ADDENDUM NO. 1  
SEWERAGE SYSTEM IMPROVEMENTS  
CONTRACT 16-01  
PEAK WASTEWATER FLOW DIVERSION  
PUMPING STATION MODIFICATIONS  
CLEVELAND UTILITIES  
CLEVELAND, TENNESSEE  
CU PROJECT NO. S2683X  
WAUFORD PROJECT NO. 4626

Date of Addendum: Wednesday, April 5, 2017

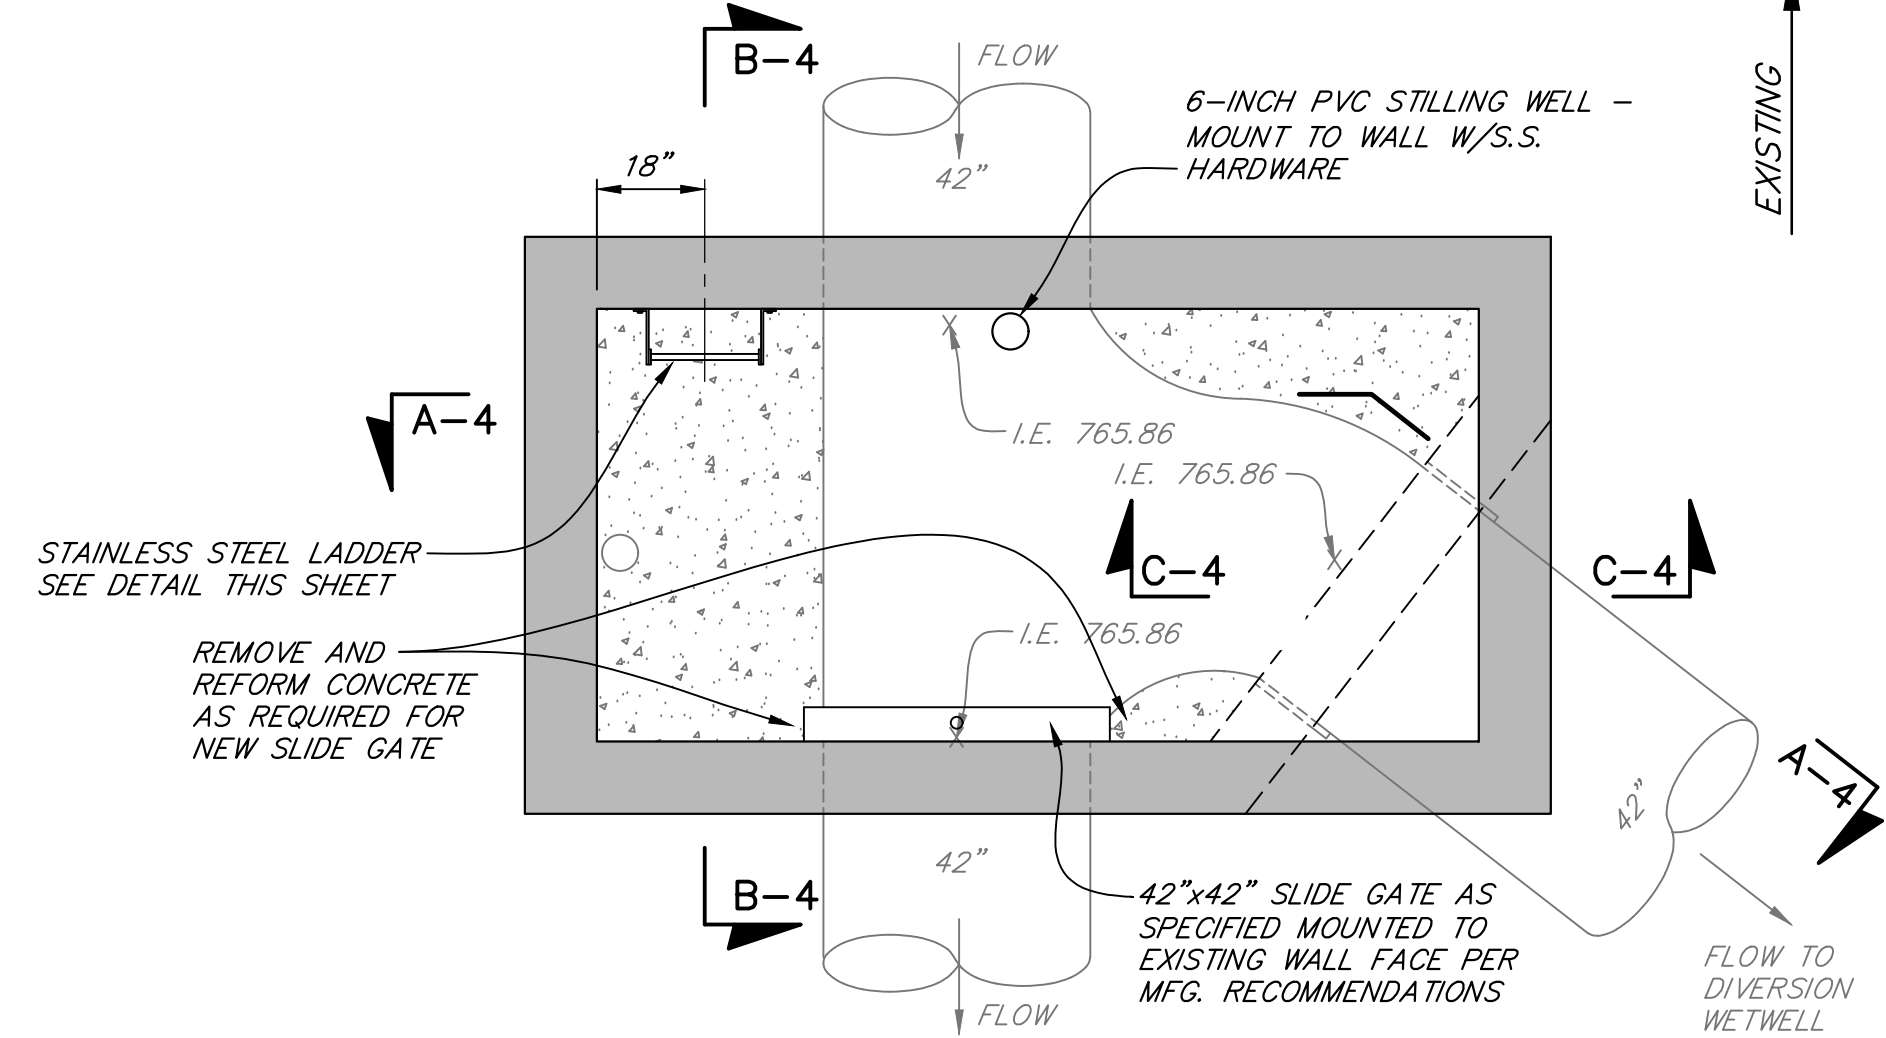
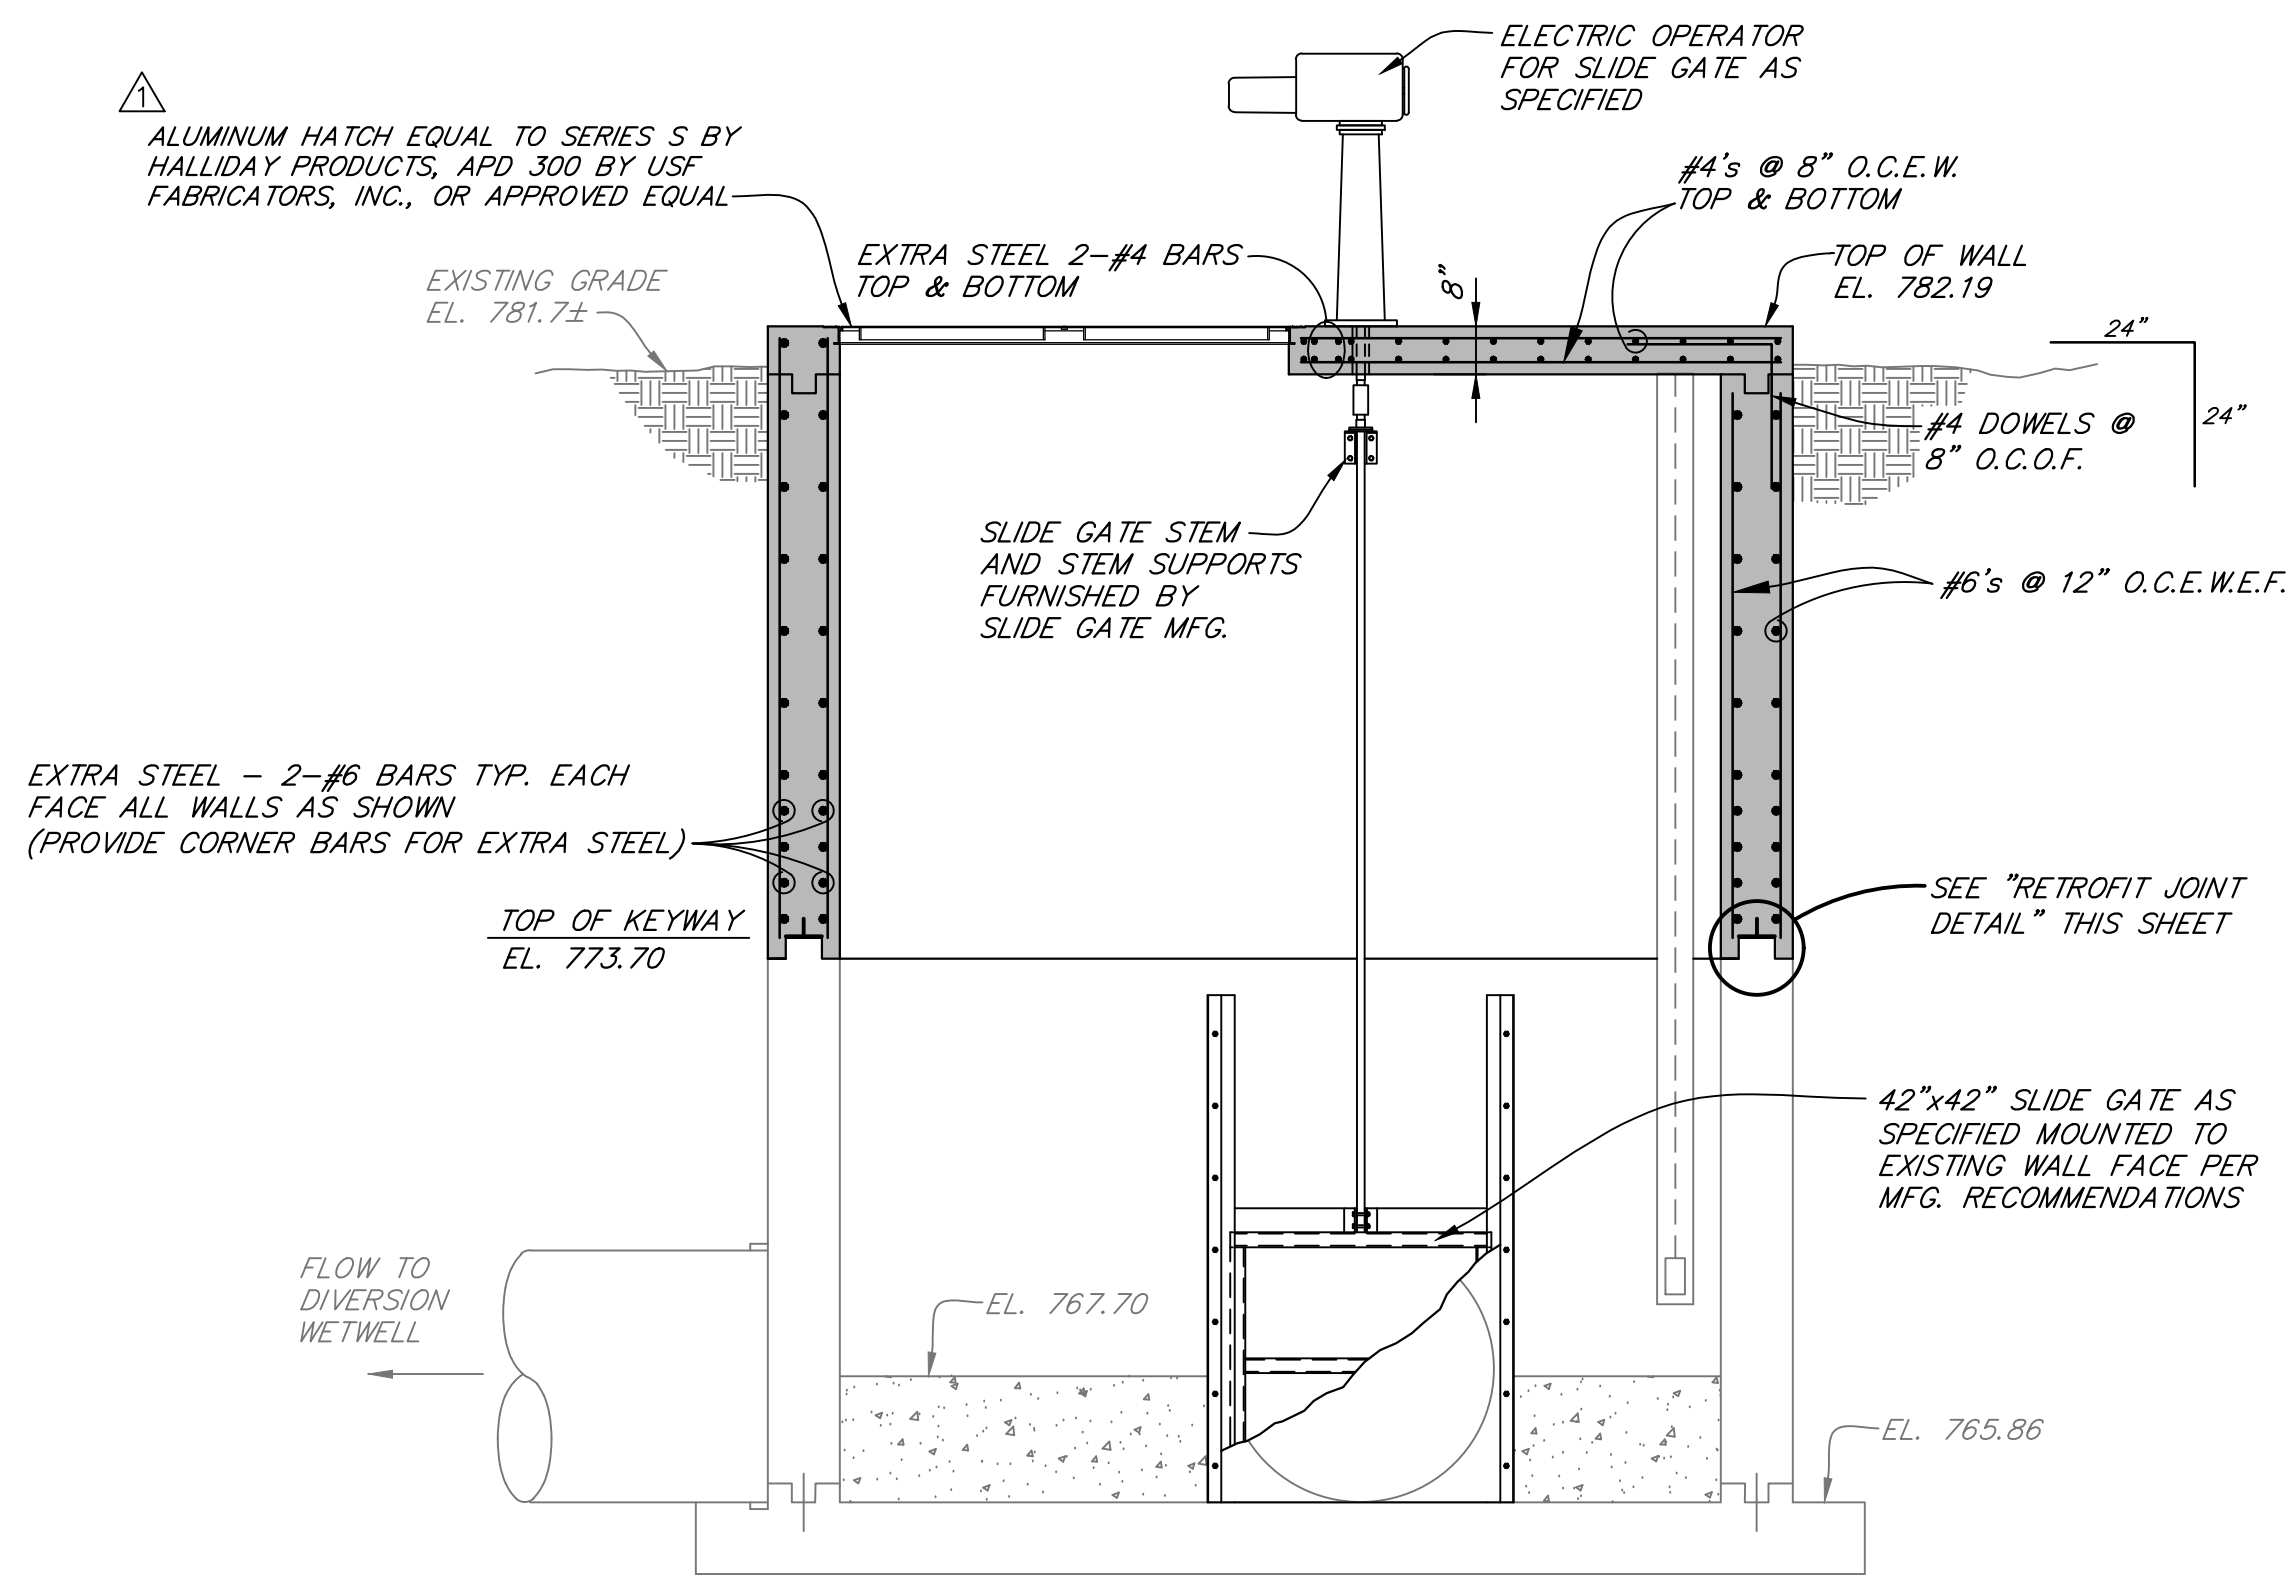
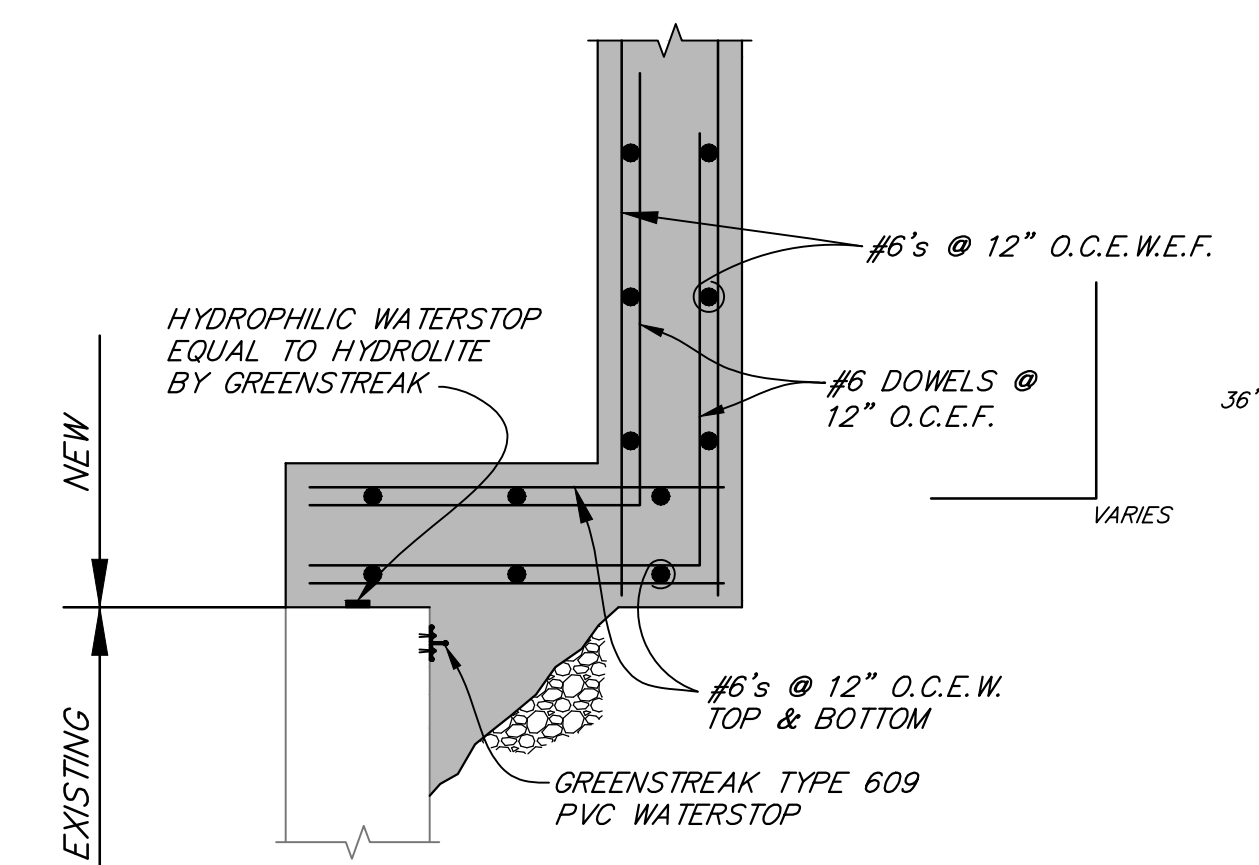
9. Plans, Sheet 4:

Revise as shown on attached Plans, Sheet 4.
